Access Compliance Report

Public Rights-of-Way

(Curb Ramps)

Intersection ID: 44467	Main Street: BUCKHORN_ST	Cross Street: ROSBERG_LN	Location: NW
ADA ID: F179A32445C3	Ramp Type: PerpDiag	Initial Pass/Fail: Fail	Overall Compliance: No
Severity Score: 17.5			
Codes/Mitigation Info/Possible Solution		Field Measurements/Component Compliance

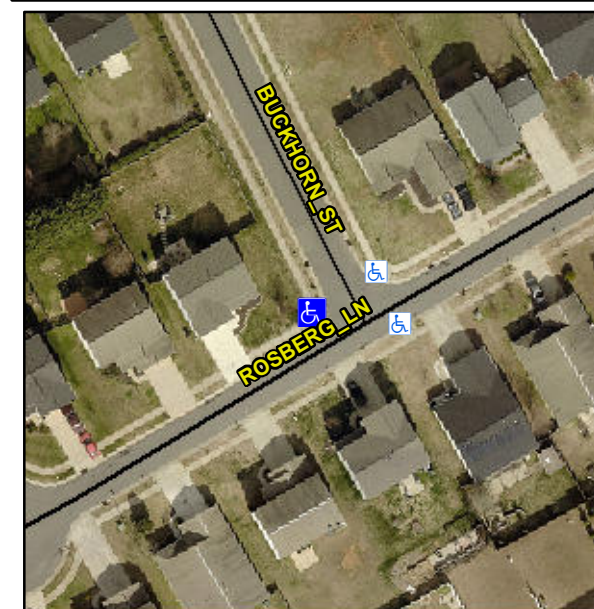
Not Found, R304.5.1

Compliance	Description	Data	Compliance	Description	Data
N/A	Ramp Length (in)	48.5	Yes	Ramp Slope (%)	7.2
No	Ramp Width (in)	32.0	Yes	Ramp XSlope (%)	0.3
N/A	Flare Type LT	N/A	N/A	Flare Type RT	N/A
N/A	Flare Slope LT (%)	N/A	N/A	Flare Slope RT (%)	N/A
N/A	Flare Traversable LT?	N/A	N/A	Flare Traversable RT?	N/A
N/A	Landing Length (in)	N/A	N/A	DWS Provided?	N/A
N/A	Landing Width (in)	N/A	N/A	DWS Contrast?	N/A
N/A	Landing Slope (%)	N/A	N/A	DWS Length (in)	N/A
N/A	Landing X Slope (%)	N/A	N/A	DWS Full Width?	N/A
N/A	Landing Curb? (Y/N)	N/A	N/A	DWS Offset (in)	N/A
N/A	Shared Landing?	N/A			
N/A	Gutter Ponding?	N/A	N/A	Gutter Slope (%)	N/A
N/A	Gutter Lip Ht (in)	N/A	N/A	Gutter X Slope (%)	N/A
N/A	Painted X Walk1?	No	N/A	Painted X Walk2?	No
	X Walk 1 Direction	To S		X Walk 2 Direction	To E
N/A	X Walk 1 Width (in)	N/A	N/A	X Walk 2 Width (in)	N/A
	X Walk 1 Slope (%)	4.1		X Walk 2 Slope (%)	3.4
	X Walk 1 X Slope (%)	1.8		X Walk 2 X Slope (%)	2.2

Remove & Replace Curb Ramp With Two New Directional Ramps or Equivalent.
